In re Application of: Jerry Jenks	)	Date: September 8, 2002
	)	
Serial N°: 09/833,978	)	Group Art Unit: 2833
	)	
Filed: 04/12/2001	)	Examiner: Luebke, R.S.
	)	
For: Electrical Interrupt Switch	)	
	)

## Request for Correction to the Drawings Under 37 CFR § 1.123

In Figure 2:

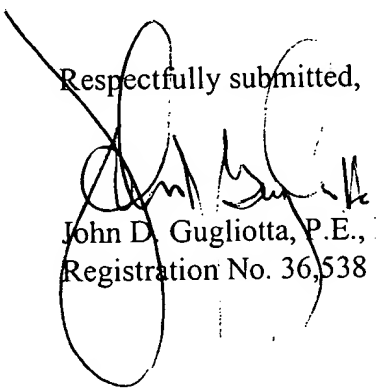
As requested and shown, please delete reference numeral "42" as indicated, while adding cross-hatching to reference numeral "18".
